# Technical Review Summary of ULI's Block 101 Proposal November 4, 2020

NORTH CENTRAL GROUP

# Current ULI Proposed Design

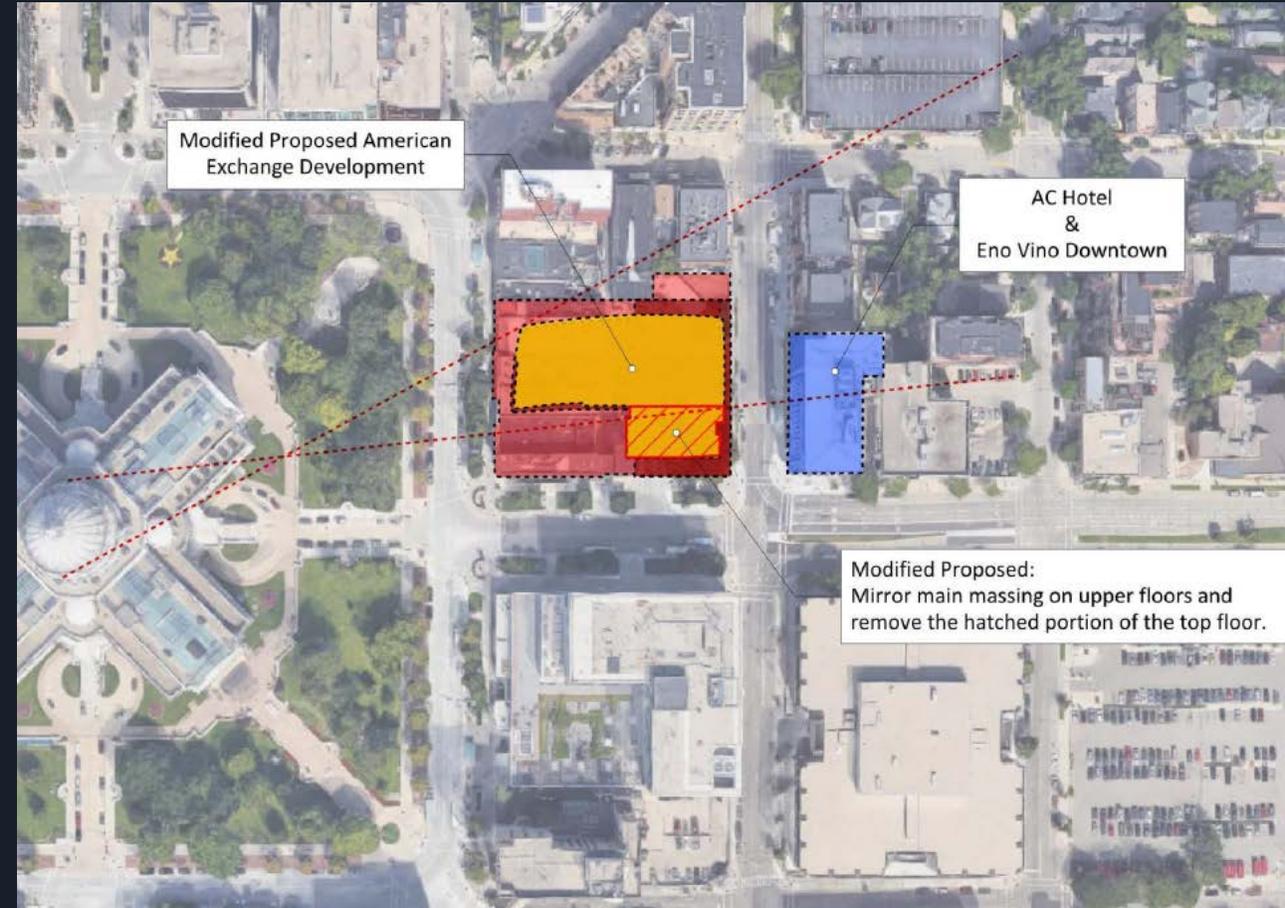
Under the proposed ULI Development, there will be a significant negative impact to the Public Views of the State Capitol. The ULI Development will block approximately 75% of the building from having a view of the Capitol dome. 15% of the building will suffer a partial blocked view of the dome, and the remaining 10% will have a partial blocked view of the Capitol building.

Sixth Floor

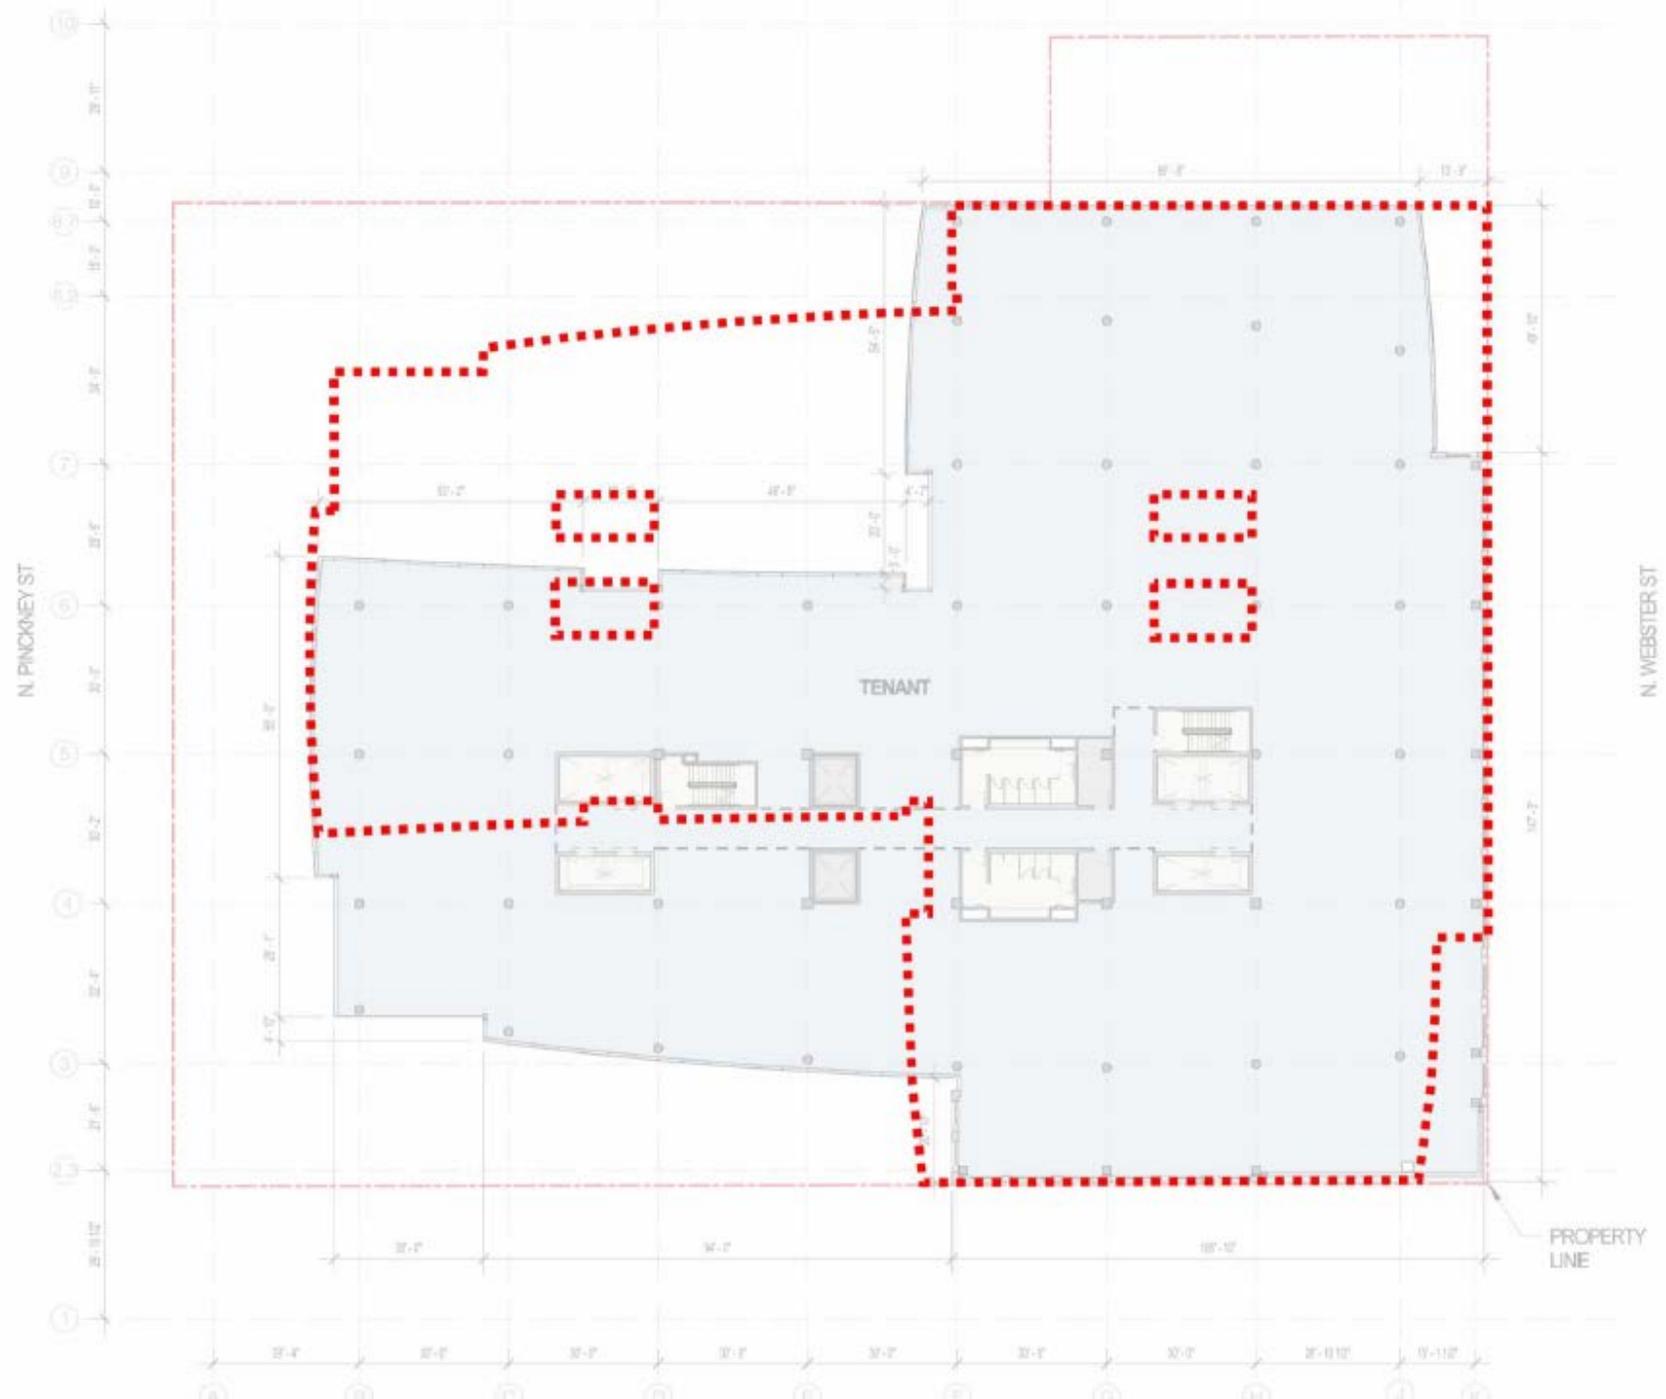
With the Proposed Modification to the ULI Development, the significant negative impact to the State Capitol view from the Public Space will be largely mitigated. The proposed modification will allow a majority of the 9th and 10th floors of the Public Space to have full Capitol Dome views. The full impact to the Capitol Dome is reduced by approximately 24%, with a majority of this percentage shifting to allow for full Capitol Dome views from the Public Spaces on the top floors.
